Portland General Electric Company

Trojan Nuclear Plant
Docket 50-344
License NPF-1

Engineered Safety Features Actuation Signals

RESOLUTION OF CRITERIA 1, 2, AND 3 FOR
SAFETY ACTUATION SYSTEM SIGNAL OVERRIDE

Figure 1 CVI Actuation/Reset

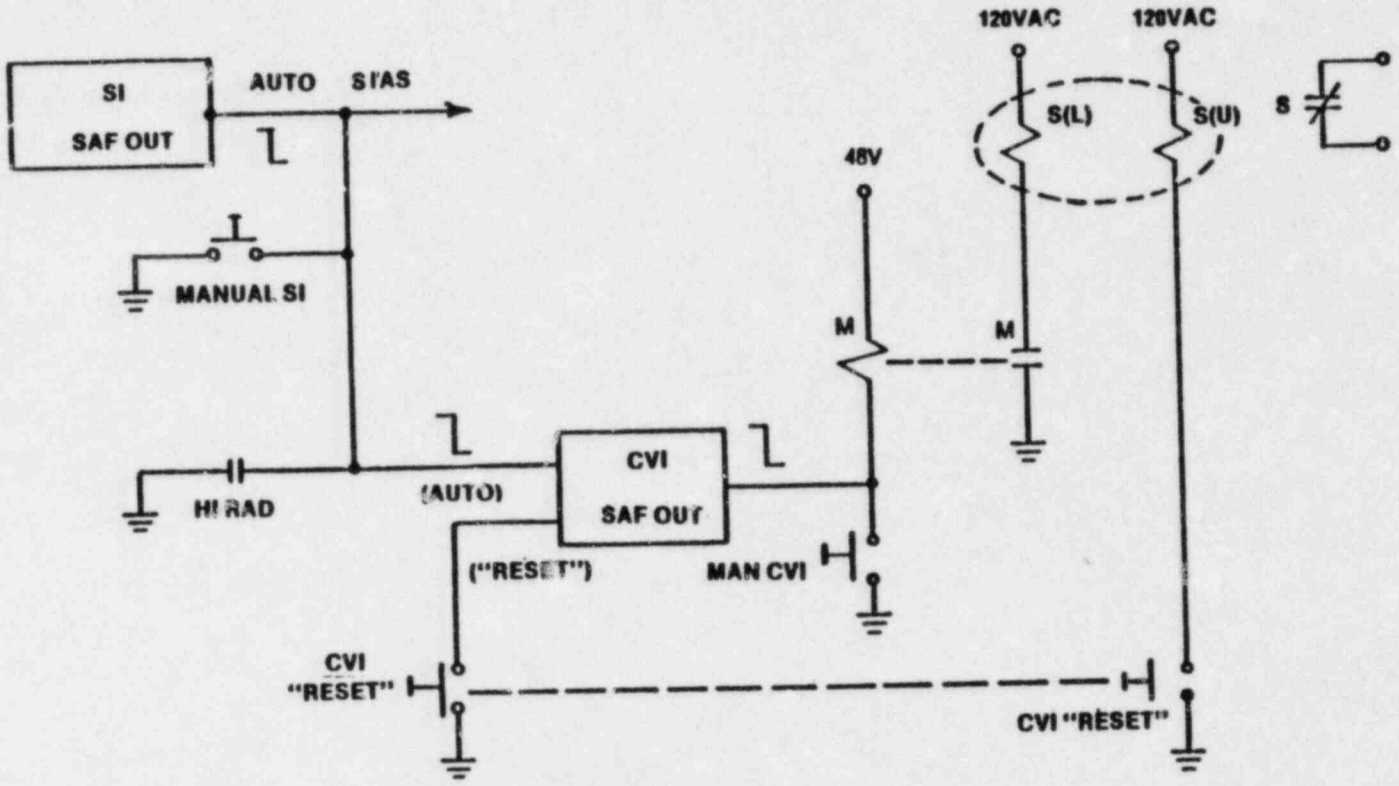
NRC Conclusion - The Containment ventilation isolation (CVI) system circuitry does not satisfy Criterion 1, since the overriding of one type of safety signal will block actuation by a second signal. We disagree with the contractor's feelings that additional procedural controls in conjunction with existing Technical Specifications will satisfy the objectives of Criterion 1.

PGE Response - In order to prevent an overriding/blocking situation from occurring in violation of Criterion 1, the Containment ventilation isolation system (CVIS) circuitry shown in Figure 1 will be modified to remove the effect of the reset push button on the CVI SAF OUT module. The lead for the reset push button from CVI SAF OUT module will be eliminated, which will remove all override capability from the CVIS circuitry. Thus, in order to reset CVIS so that the Containment purge valves and hydrogen vent valves can be reopened, all incoming trip signals to the CVIS circuitry must clear or must be blocked at their source. Upon completion of this modification, Criterion 1 will be satisfied for the CVIS. This modification is expected to be complete by January 1, 1984.
